Property reference: Tax Map U36/Lot 0010

Major Site Plan Review Application

Change Order Scope of Work

306 60'x16'x50' (#1)

Eyebrows

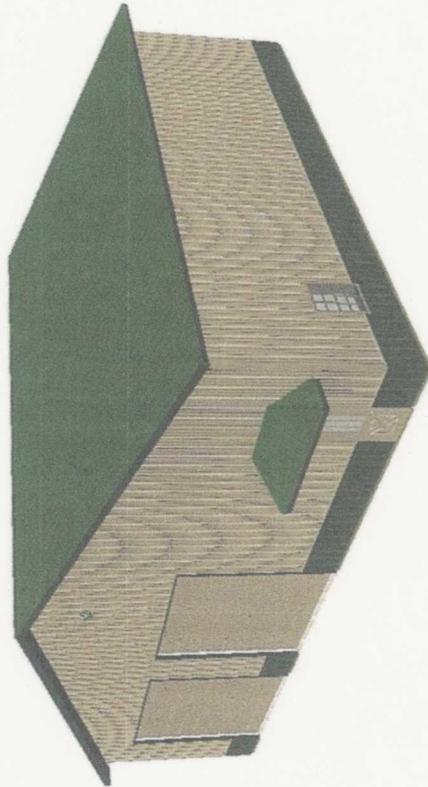
Removed

"E" - 12 lineal feet of coverage, 3' wide Eyebrow, 6" fascia with 10/12 roof pitch, 8' grade to soffit
Start eyebrow on West wall 1 feet from left edge of building for 12 feet
Start of eyebrow Hipped End and end of eyebrow Hipped End
Roof of eyebrow to be Fluoroflex™ 1000 Hi-Rib Steel
without Gutter

Added 11 lineal feet of coverage, 3' wide Eyebrow, 6" fascia with 10/12 roof pitch, 8' grade to soffit
Start eyebrow on West wall 48 feet from left edge of building for 11 feet
Start of eyebrow Hipped End and end of eyebrow Hipped End
Roof of eyebrow to be Fluoroflex™ 1000 Hi-Rib Steel
without Gutter

Perspective From The Southwest

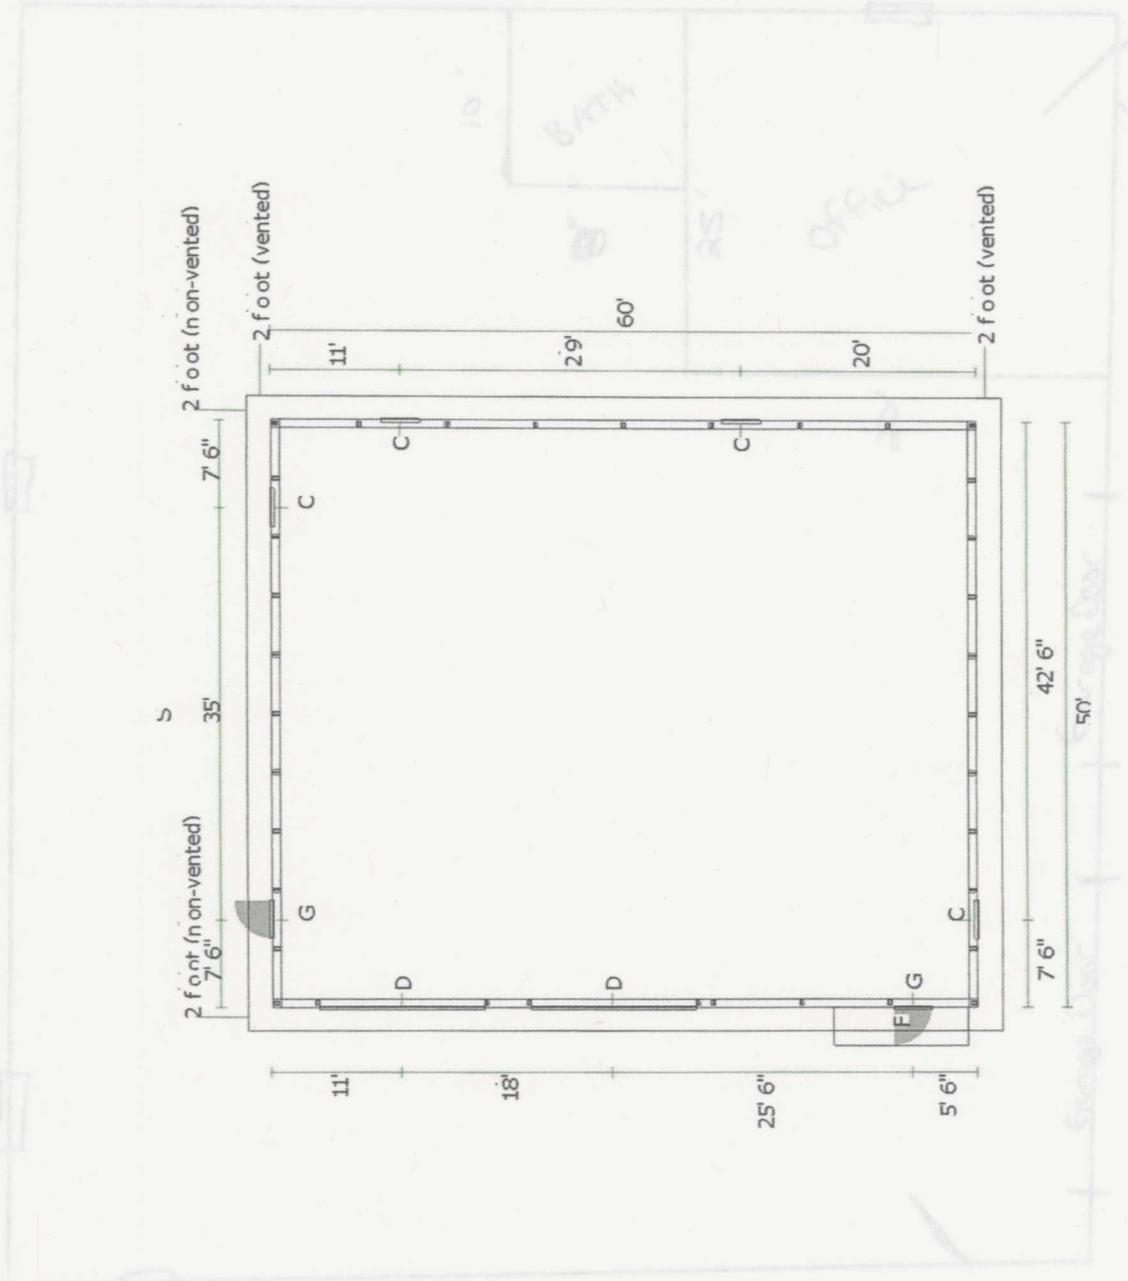
MOVE OVERHEAD DOORS, WALK DOORS, AND WINDOWS PER OWNERS REQUEST

Removed "A" - 3' x 6'8" 9 Lite Tempered Glass in Leaf with Embossed Crossbuck Fibersteel Walk Door(s) out-swing right hinge with interconnected lever lockset/deadbolt, closer from 7' 6" on the South wall

Removed "B" - 3' x 6'8" 9 Lite Tempered Glass in Leaf with Embossed Crossbuck Fibersteel Walk Door(s) out-swing left hinge with interconnected lever lockset/deadbolt, closer from 3' 6" on the West wall

Added "G" - 3' x 6'8" 9 Lite Tempered Glass in Leaf with Embossed Crossbuck Fibersteel Walk Door(s) out-swing left hinge with interconnected lever lockset/deadbolt, closer from 54' 6" on the West wall

Added "G" - 3' x 6'8" 9 Lite Tempered Glass in Leaf with Embossed Crossbuck Fibersteel Walk Door(s) out-swing left hinge with interconnected lever lockset/deadbolt, closer from 42' 6" on the North wall

Removed "C" - 3'4"x4'0" MB Single Hung Window(s) with low E glass with argon, grids between the glass from 10' on the West wall

Removed "C" - 3'4"x4'0" MB Single Hung Window(s) with low E glass with argon, grids between the glass from 42' 6" on the North wall

Added "C" - 3'4"x4'0" MB Single Hung Window(s) with low E glass with argon, grids between the glass from 49' on the East wall

Added "C" - 3'4"x4'0" MB Single Hung Window(s) with low E glass with argon, grids between the glass from 20' on the East wall

Moved "C" (3'4"x4'0" MB Single Hung Window(s) with low E glass with argon, grids between the glass) from 42' 6" on the South wall to "C" 7' 6" on the South wall

Moved "D" (14'0" x 14'0" Overhead Door Opening, 14' 2" X 14' 1" Panel, 2' Headroom
See Subcontract Section for Detailed Door Information) from 49' on the West wall to "D" 29' on the West wall

Moved "D" (14'0" x 14'0" Overhead Door Opening, 14' 2" X 14' 1" Panel, 2' Headroom
See Subcontract Section for Detailed Door Information) from 31' on the West wall to "D" 11' on the West wall
